**FINDINGS AND RECOMMENDATION
OFFICE OF PLANNING AND ZONING
ANNE ARUNDEL COUNTY, MARYLAND**

CASE NUMBER: 2024-0135-V

The applicant is requesting a variance to allow dwelling additions (second story over existing first floor and two-story addition) with less setbacks than required on property located at 656 Shore Road in Severna Park.

LOCATION DRAWING OF:
#656 SHORE ROAD
LOTS 1, 2 & PART OF 3 & 4, BLOCK 2
PLAT BOOK 2, PLAT 23
CARROLLTON MANOR
LIBER 2688, FOLIO 889
ANNE ARUNDEL COUNTY, MARYLAND
SCALE 1"=30' DATE: 10-31-2023
DRAWN BY: AP FILE # 238582-152

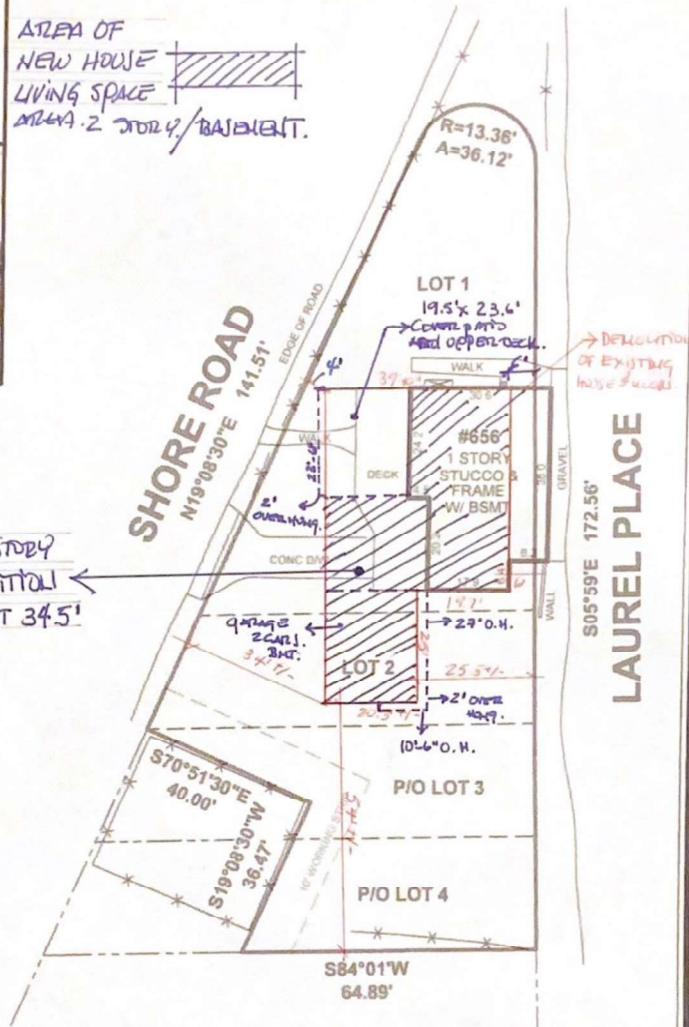
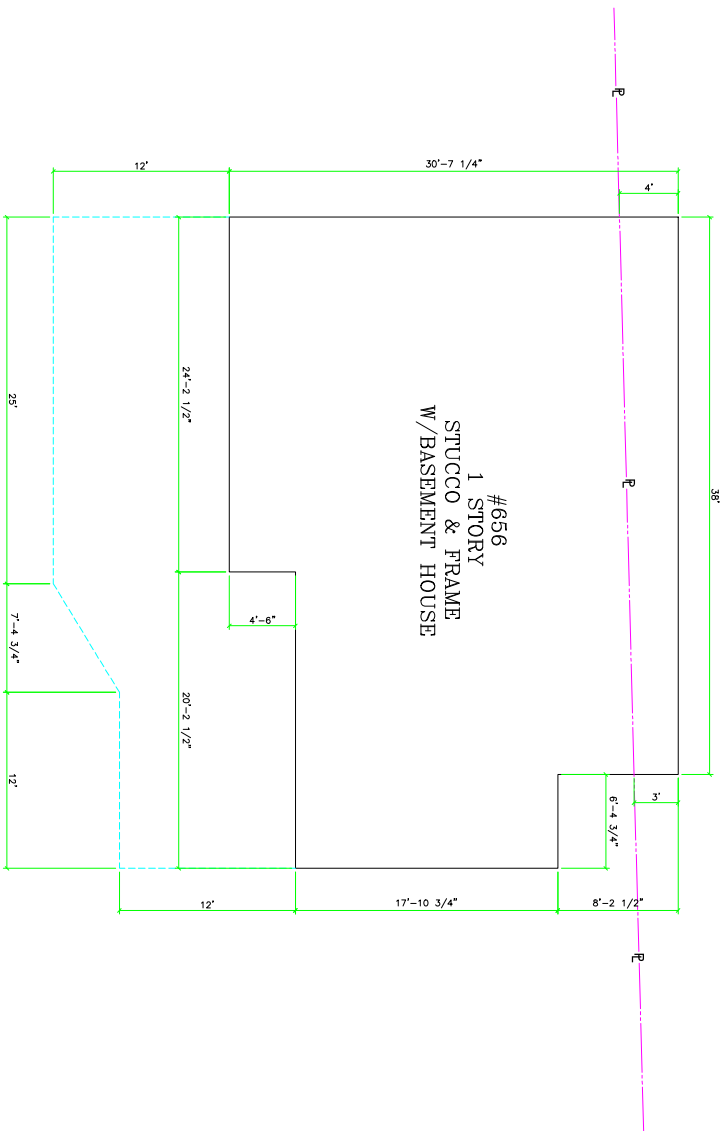
§ 18-4-701 of the Anne Arundel County Zoning Code provides that a principal structure in an R5 District shall be set back a minimum of 25 feet from the front lot line and 20 feet from the corner side lot line. The proposed dwelling additions would be constructed as close as four feet from the front lot line (abutting Shore Road) and as close as six feet from the corner side lot line (abutting Laurel Place), necessitating variances of 21 feet and 14 feet, respectively.

A review of the 2024 County aerial photograph shows an eclectic mix of dwellings in this older waterfront community. According to State tax assessment records, the subject dwelling was constructed in 1951, prior to the enactment of zoning regulations. The existing house is located near the intersection of Shore Road and Laurel Place, in an acutely angled area of the site, causing expansion to be problematic without setback relief. A portion of the existing dwelling (approximately 4' by 38') encroaches into the Laurel Place right-of-way.

Approval of the variances may alter the essential character of the neighborhood, as the substantial three-level addition would be located a mere four feet from the front lot line, having a significant visual impact on the streetscape. The variances would not substantially impair the appropriate use or development of adjacent properties, as the additions would exceed the minimum setback required from the only adjacent property. There is no evidence to indicate that the variance would be detrimental to the public welfare.

Given the unique lot shape and the nonconforming location of the existing house within an acutely angled portion of the property, it is clear that some setback relief is warranted. However, it does not appear that any consideration was given to the shape of the lot when designing the proposed additions. The dwelling could have been designed to be more respectful of the front setback by expanding a lesser distance to the west and extending more to the south. In fact, given that the area of the proposed addition that is closest to the front lot line is an excessive 19.5' by 23.6' multi-level porch/deck area, the applicant could have reduced or angled that area in order to minimize the requested front variance.

The applicant's letter of explanation provided no justification for the variances at all, nor did it explain what alternatives were considered and why the current proposal represents the minimum variances necessary to afford relief. Alternative options exist that would minimize the front setback variance in order to lessen the visual impact on Shore Road. Therefore, the variances cannot be supported as proposed.

Based upon the standards set forth in § 18-16-305 of the Code under which a variance may be granted, this Office recommends ***denial*** of the proposed zoning variances to § 18-4-701.
